October 19, 2015

Subject: Input for the National Remedy Review Board Meeting on the Portland Harbor Superfund Site from the RM11E Group

Draft Implementability Study Report

Supplemental Remedial Investigation/Feasibility Study

DRAFT - FOR REVIEW	
RM11E Group	
Willamette River - Portland, Oregon	
Draft Implementability Study Report	
Waterfront Facilities	
DOF DALTON OLMSTED FUGLEVAND	
Figure 9.1	
July 31, 2015

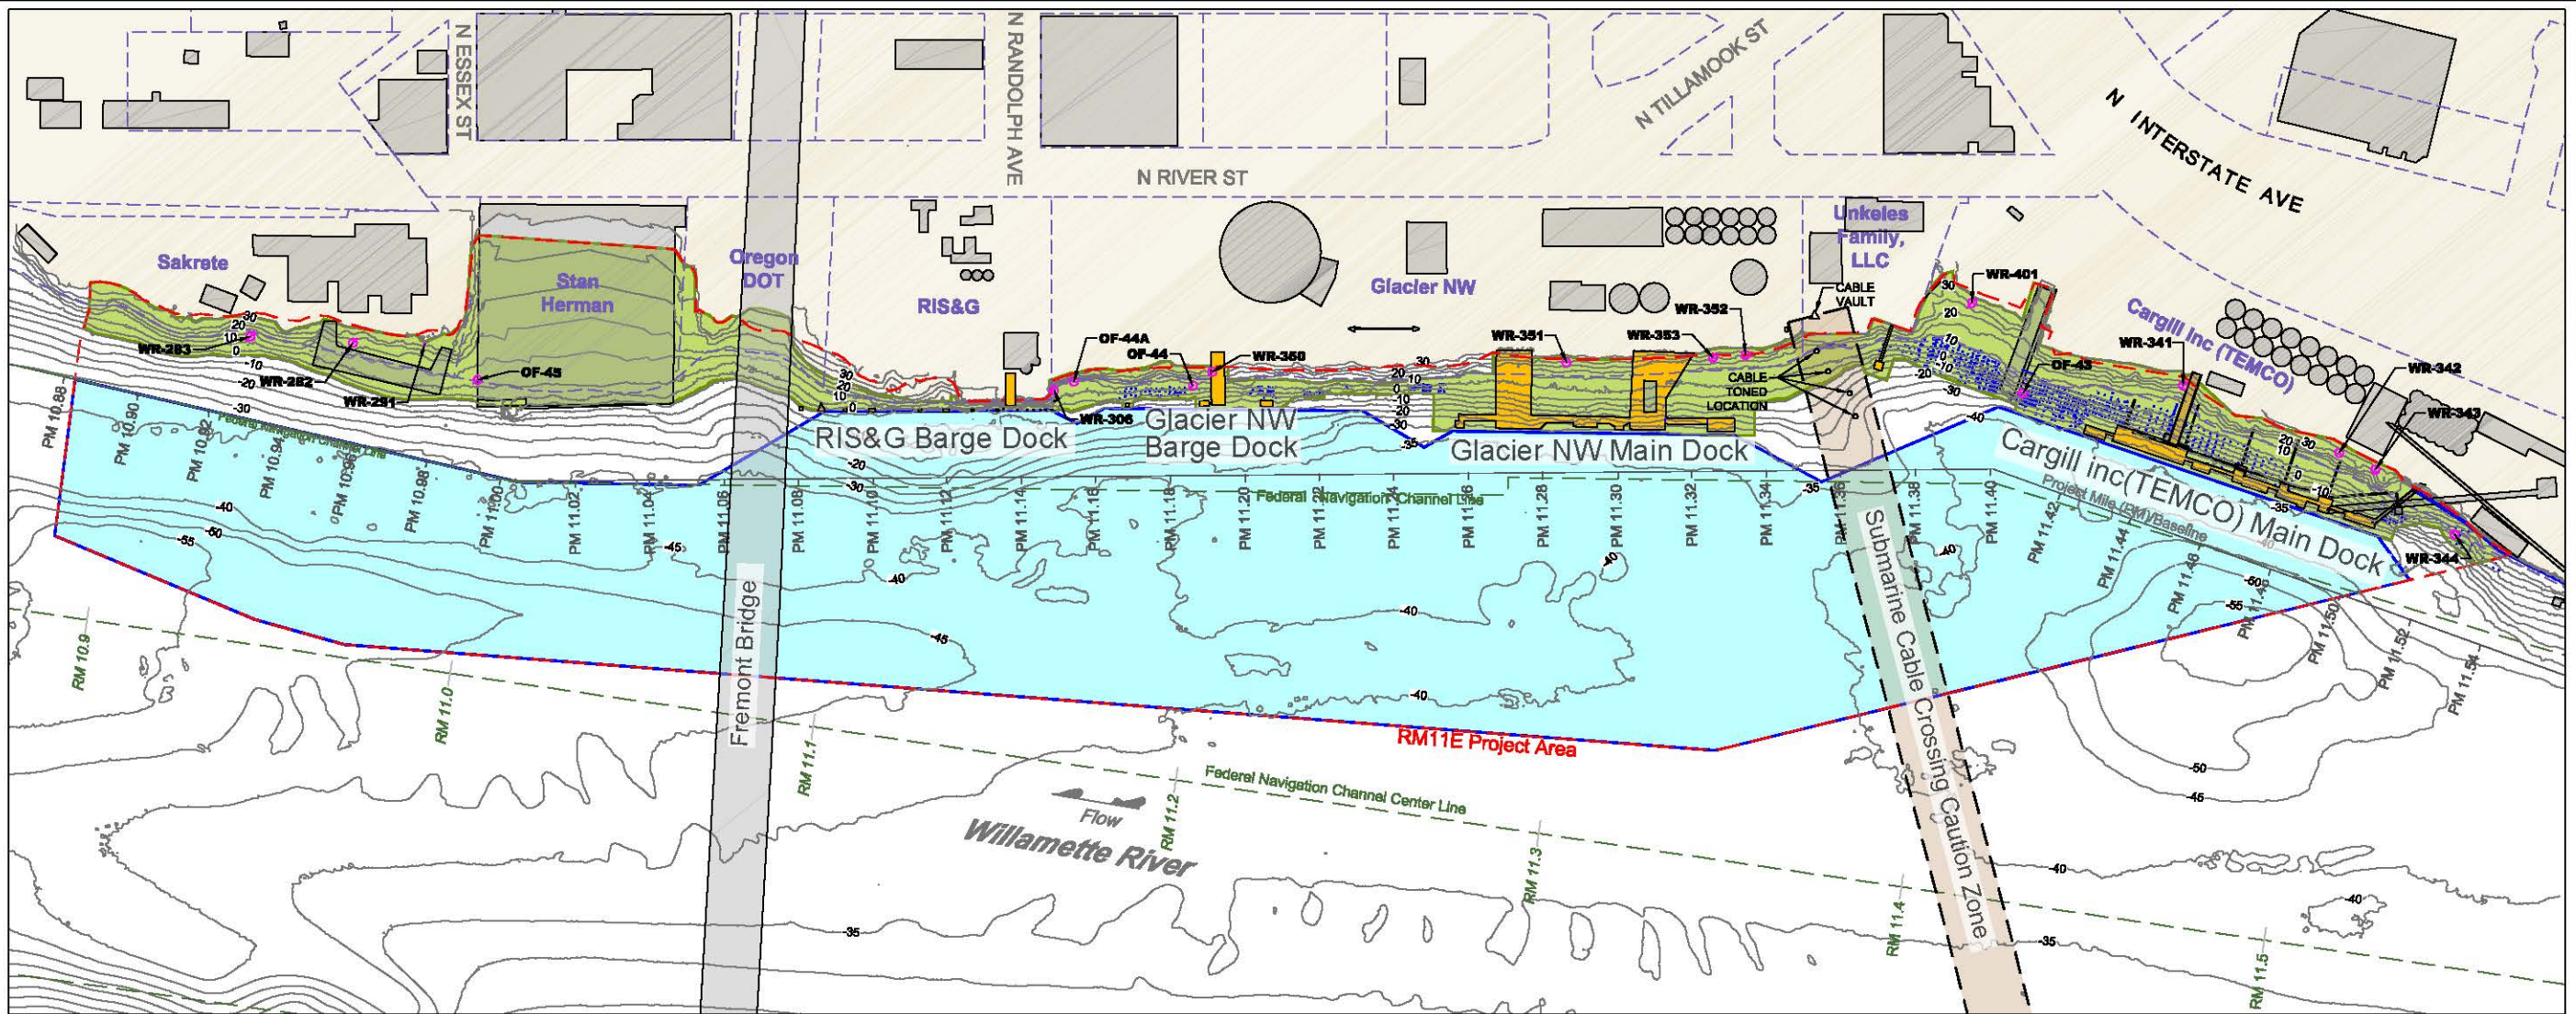
Conclusions: The ODFW-allowed in-water construction season, which occurs when remediation would normally take place, coincides (and conflicts) with the busiest periods of shipping operations at the RM11E Project Area. Restricting remediation to the in-water work window will cause significant implementability challenges.

Conclusions: Numerous docks and structures in various structural conditions are present throughout the RM11E Project Area. Most are located along the shoreline in areas of oversteepened slopes. Changes to the soil loading conditions due to dredging or capping activities can reduce stability and capacity for these structures. Dredging to remove more than 5 feet of sediment at or near existing structures poses a higher risk to structure stability than does shallower dredging and cap placement.

Recommendations: With agency authorization, expand the in-water work windows to continue or complete remedial actions outside the period of peak shipping activities. Consider sequentially

remediating portions of the RM11E Project Area using a phased or staged approach, so that remedial work can be coordinated with facility-specific operations.

Recommendations: Limit dredging around structures where possible through application of non-removal remedial technologies (e.g., MNR, EMNR, in situ treatment, engineered caps, and active caps). If necessary and practical, stabilize the slopes and structures to protect the integrity of a structure during and following remediation.

Figure 9.2

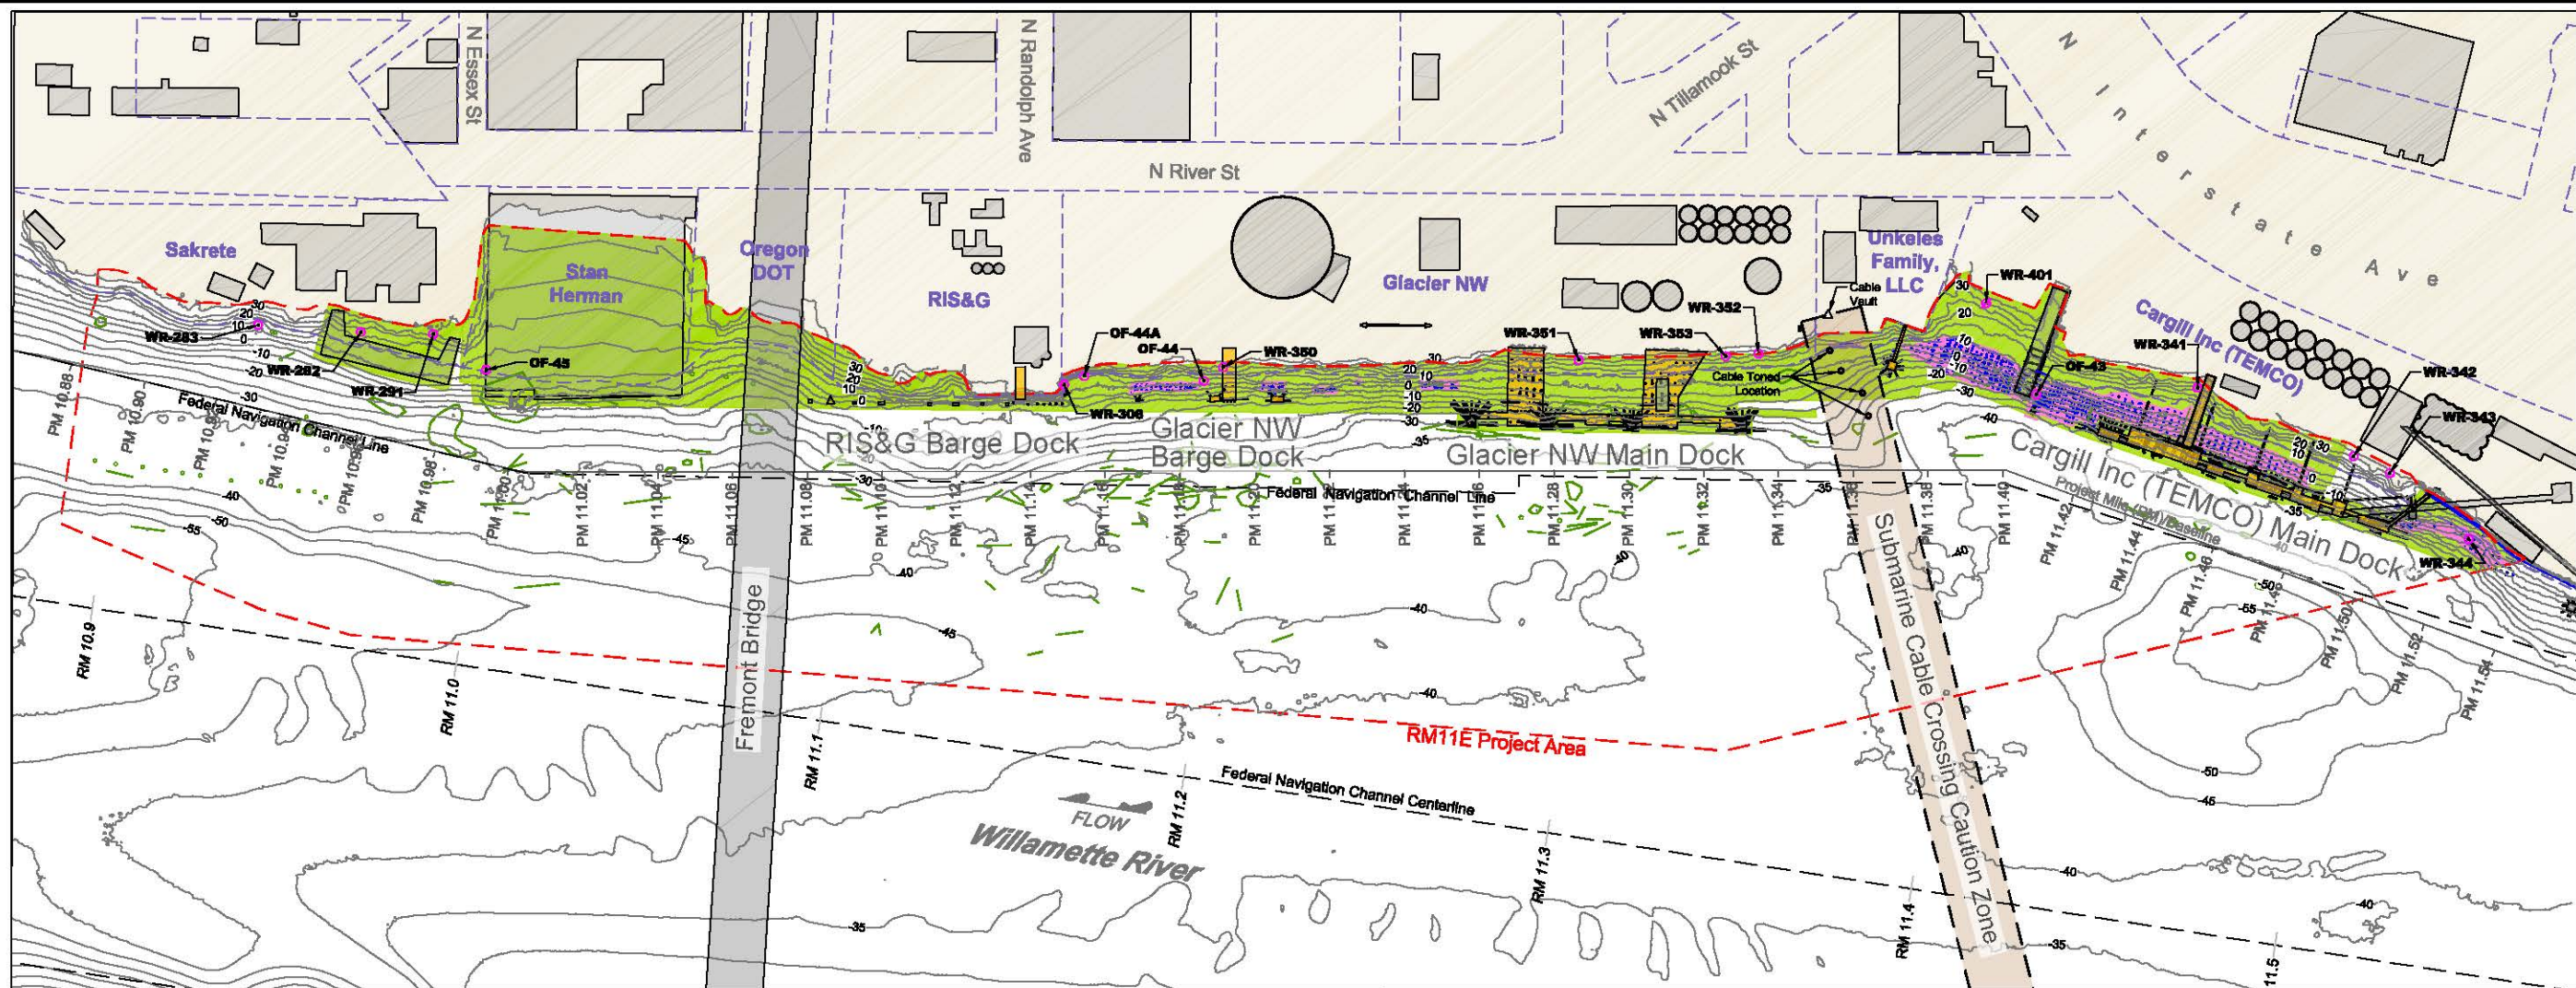
Conclusions: Engineered capping in deep-draft navigation areas (i.e., the navigation channel, deep-draft berths at Glacier NW and Cargill, and associated approach areas) is not likely to be a viable option if the navigation clearances as noted in the PHSS Draft FS are required. Prior to constructing such a cap, it would be necessary to over dredge these areas to depths lower than the riverbed elevation to ensure that navigation clearance is maintained. This dredging would likely result in full removal of impacted material before the desired depth for cap construction is reached, thus negating the need for a cap.

Conclusions: Numerous areas within the shoreline and berth area of the RM11E Project Area are not accessible from the water by conventional marine construction equipment or from upland properties because of waterfront structures, groups of vertical pile remnants, shallow draft areas, and steep shorelines.

Conclusions: The presence of a submarine electrical power cable crossing through the RM11E Project Area precludes dredging as well as anchoring and spudding of marine construction equipment in the cable corridor.

Recommendations: Limit or avoid construction of thick engineering caps in deep-draft navigation areas where navigation clearance cannot be maintained. Revisit the navigation clearance and cap thickness requirements to determine where capping may be viable in navigation areas. In deep-draft navigation areas, consider low-profile remedial solutions, such as MNR, EMNR, in situ treatment, reduced thickness caps, and articulated concrete caps. Implement dredging as a remedial option where engineered capping or low-profile remedies are not viable.

Recommendations: For caps in locations with limited access, deliver capping material via telescoping conveyor belts or slurry pipelines. For dredging in areas that cannot be accessed otherwise, use shallow-draft marine construction equipment (e.g., small excavator dredges on portable barges) and diver-guided hydraulic dredges. Consider implementing remedial actions that require only limited use of marine construction equipment (e.g., MNR, EMNR, in situ treatment).

Recommendations: If active remediation is required in the submarine cable crossing caution zone, conduct additional investigation to refine the location and burial depth of the energized cables, to the extent possible. Establish a no-dig zone in the area of the submarine cables. Incorporate remedial actions involving only limited disturbance of sediment (e.g., MNR, EMNR, in situ treatment) in the cable crossing caution zone as well as capping in areas outside of deep-draft navigation.

Figure 9.3

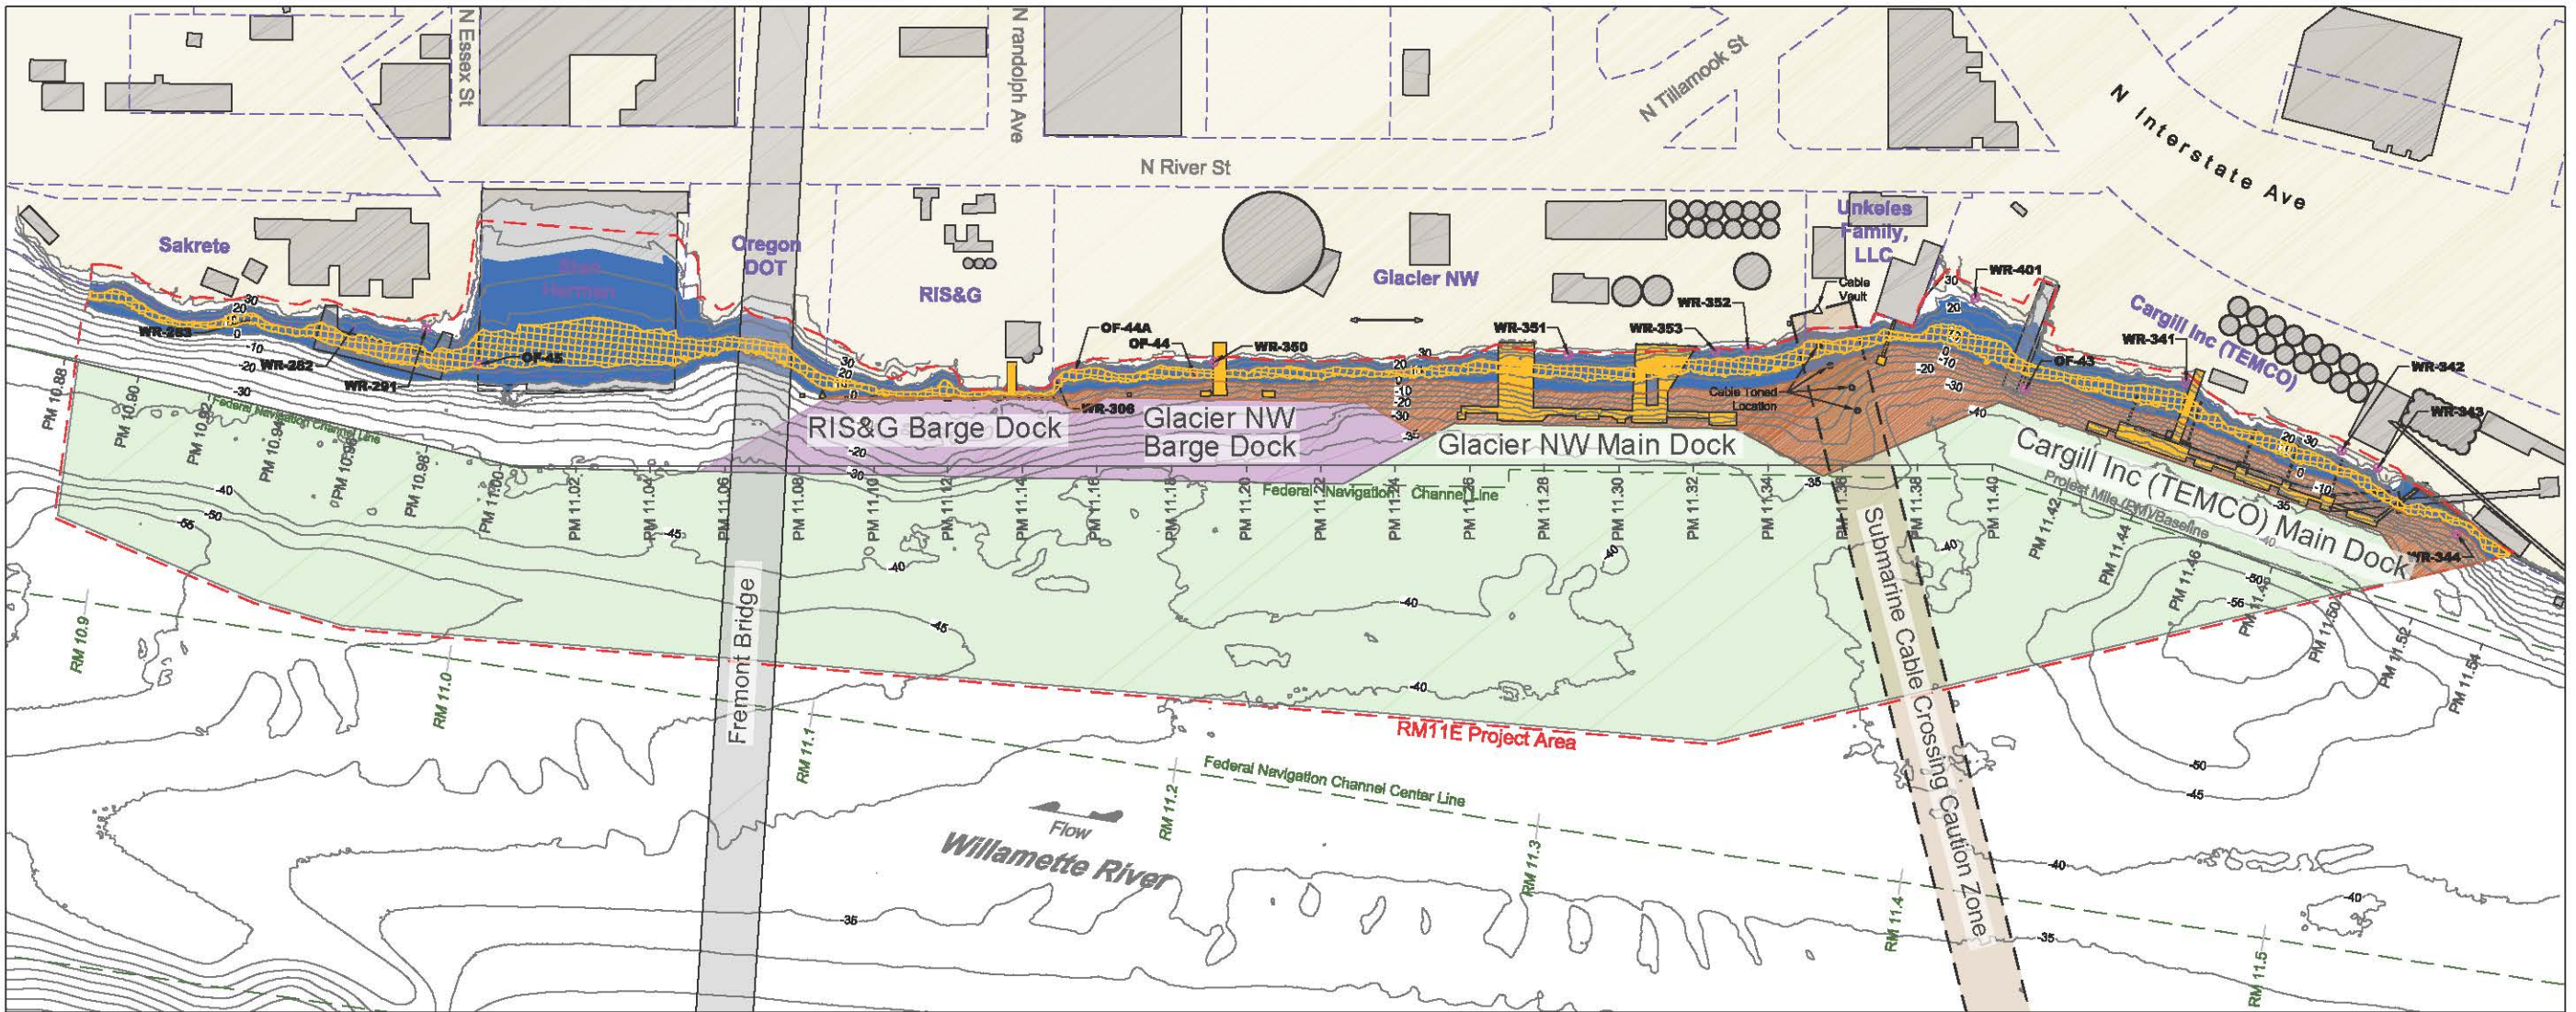
Conclusions: Large areas of remnant timber piles exist along the shoreline within the extents of historical shoreline structures, predominantly behind the Cargill main dock, and to a lesser extent north of the Glacier NW main dock. Removal of remnant piles near the shoreline may diminish slope stability and could result in slope failures. Groups of vertical pile remnants limit access for

marine construction equipment, prevent a dredge bucket from achieving complete removal of target sediment, and complicate the placement of a cap by limiting the achievement of a uniform cap thickness. If left in place, piles that extend through the cap could diminish the cap effectiveness.

Conclusions: Large undifferentiated debris is expected along the shoreline of the RM11E Project area, primarily within the extents of historical shoreline structures. The debris will complicate and diminish the effectiveness of dredging, its removal could potentially destabilize slopes.

Recommendations: For caps within groups of vertical pile remnants, consider cutting off piles near the riverbed and increasing cap thickness to account for irregular placement around pile remnants. For dredging within groups of vertical pile remnants, consider diver-operated hydraulic equipment to remove thin deposits of sediment in limited areas. Incorporate MNR, EMNR, and in situ treatment where appropriate.

Recommendations: In areas where large undifferentiated debris is expected, limit dredging in favor of non-removal technologies (e.g., MNR, EMNR, in situ treatment, engineered capping, and active capping). Where dredging is required, use mechanical dredging and include contingency plans to map debris fields as they are uncovered, and provide for the use of marine construction tools specific to debris recovery. Implement practices to manage turbidity generated during removal of large undifferentiated debris.
